**INFORMAL REFERRAL COMMENTS – DA 090/M009/18 (2018/19332/01)
22-28 ANZAC HIGHWAY & 6-14 THIRD AVENUE EVERARD PARK/FORESVILLE**

Our Ref: 2018/19332/01

Application Number: 090/M009/18

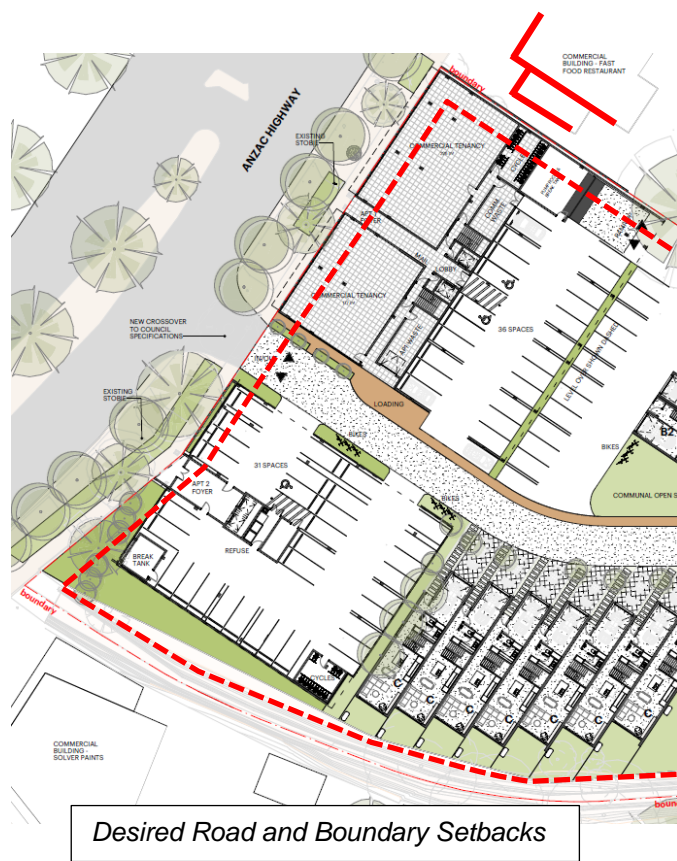
- The Building Height maximum is focussed as desired towards the Anzac Highway frontage;
- Building Height transitions down to desired 2-3 storey adjacent to the lower density zone interfaces and the Third Avenue frontage. The 3rd level to the Third Avenue frontage has an increased setback but lower ground and first floor levels encroach into desired minimum 6.0 metres setback (4.4 metres). A 2 storey height, increased setback, articulation and further recessed 3 storey element would be preferred to relate better to the context of the low scale traditional dwelling nature opposite and interface with the Residential Streetscape (Built Form) Zone high integrity character nature;

- Building Envelope, 30° at 3.0 metres above ground level at the zone boundary, largely appears likely to accord but this is not uncertain. No critical cross-sections are provided to confirm this or if any level of variation occurs and needs detailed assessment;

- The proposed development does not respect fundamental policy on some fundamental urban design and desired character policy, viz setbacks;
- Anzac Highway, as a grand boulevard, seeks a critical 3 metre building setback to achieve a desired character of complementary landscaped frontage, building separation and residential amenity. The space should be landscaped to complement boulevard space and character but may also have limited areas for activities for outdoor dining and/or goods displays. It is not a main street or suitable for a hard edged urban environment.

- A 0.0m and lesser setback than minimum 3.0 metres should be avoided. Indicated impractical to be ‘tucked ... behind’ and follow ‘weak edge’ from existing development to north. KFC is setback 5.7 metres (small cantilever canopy at 3.7 metres) and 8.9 metres to drive-thru canopy on south side. Policy is about observing a fundamental future desired character with new development;

- Side boundaries should provide for 3 metres setbacks to separate development mass between properties and allow softening landscaping. Minimal 0.6 metres setback to northern boundary (offset to sound attenuation 3.5 – 4.5 metre high wall to KFC on boundary) is proposed compromising desired character and potential development opportunities for the adjoining site;

Third Ave Built Form and Setbacks

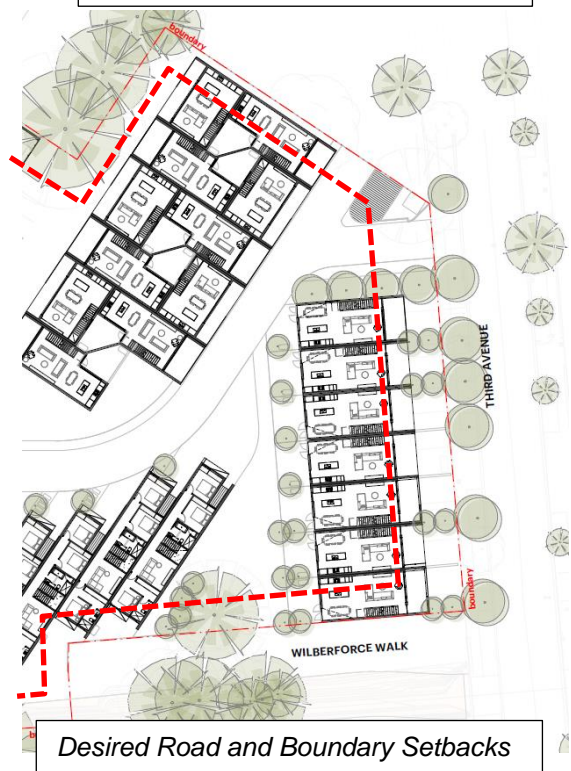
- The proposed development provides increased scale and single bulk 3 storey development with inadequate limited setback relief:
 - ground level – 4.4 metres to protruding side walls, 5.2 metres to garage wall (5.4 metres to recessed garage door), also compromising space for vehicle parking to be contained on-site with adequate personal access manoeuvring space around front and rear, and 6.6 metres to entry door;
 - second level – 4.4 metres to balcony balustrade and feature full height screens and 6.8 metres to bedroom wall and glazing behind;
 - third level – 7.3 metres to protruding side walls, 8.0 metres to window and wall and 8.7 metres to recessed minor stair component;

- Third Avenue street setback should observe minimum of 6.0m metres, with further building mass articulation and additional notable relief to 3rd storey level above;
- Inadequate setback relief and building mass is compounded by the series of driveways, majority of paving and lack of any substantial front yard landscaping. Provision for increased street trees is noted but does not fully address open aspect to extensive paving, minimal landscaping and building mass. Loss of on-street parking also compounds on-site parking shortfall – refer Council Issues below;

- Vehicle access for the 4 northern row dwellings could be provided off the common driveway from the rear to reduce street crossovers, extent of paving and lack of landscaping;
- Side boundary to north provides for 1 metre setback rather than desired 3 metres to separate development mass between sites and allow softening landscaping;
- Wilberforce Walk is technically a public road where a minimum 2.0 metre setback is applicable, plus respecting building envelope. Given it is not used as a road, generous separation is provided to adjoining property and the opportunity exists to create a landscaped space around the development the lack of a setback is less critical.;

Open 'Gabion' Channel and Parallel Shared Path

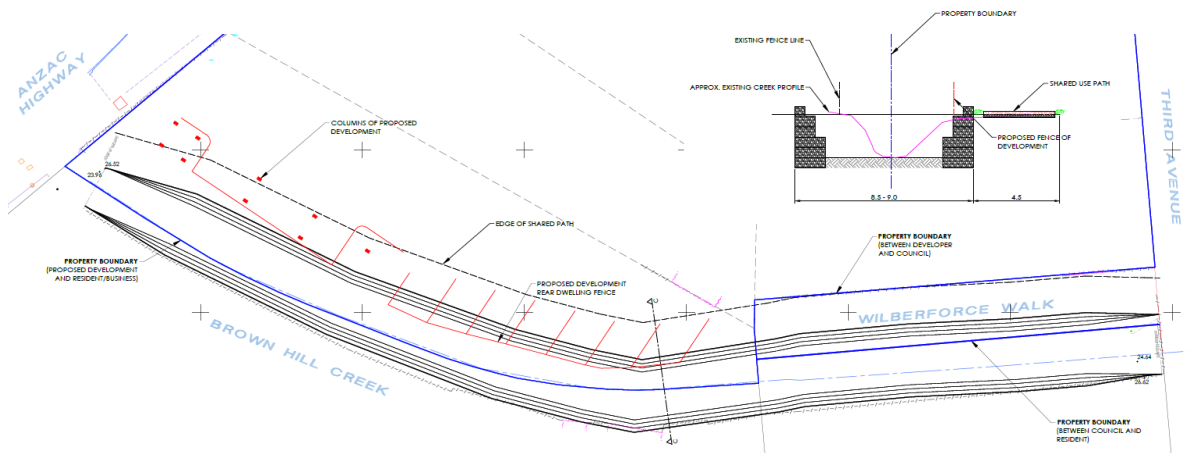
To achieve an upgraded open channel and a parallel shared path link requires a substantial increased corridor of land, involving additional land on the south side of the creek and substantial intrusion into the subject development site.

While an effective approach, it is undesired and impractical, with inferior safety, reduced amenity, significant intrusion and higher land cost.

Enclosed 'Culvert' and Encompassed Shared Path

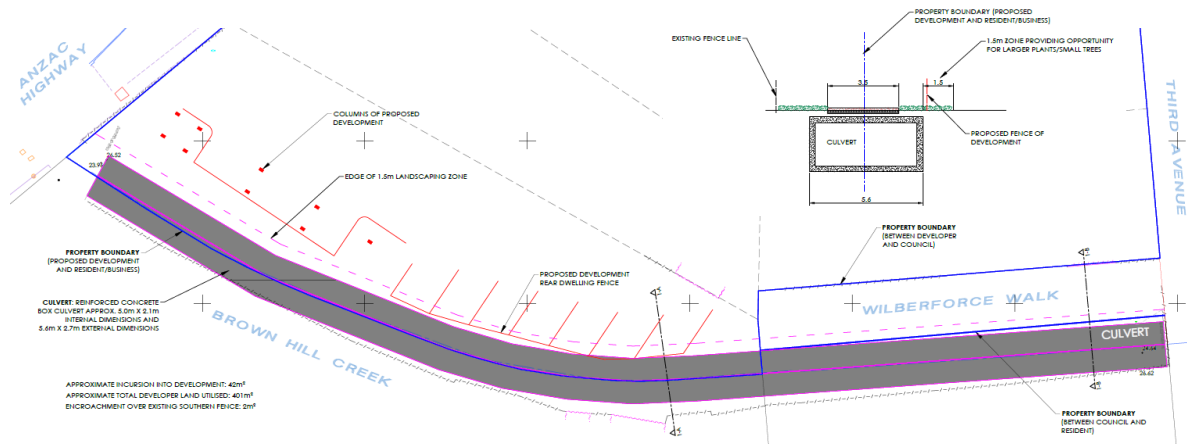
More practical, efficient and preferred is a 'culvert' option with encompassed shared path and landscaping on and alongside to create a minimised land corridor and high amenity open-space link.

The 'culvert' option costs more but requires less land, plus affords amenity benefits. While combination with Wilberforce Walk may allow for an alternative approach it is a limited section and water flow needs to be smooth making a continuous culvert the preferred outcome.
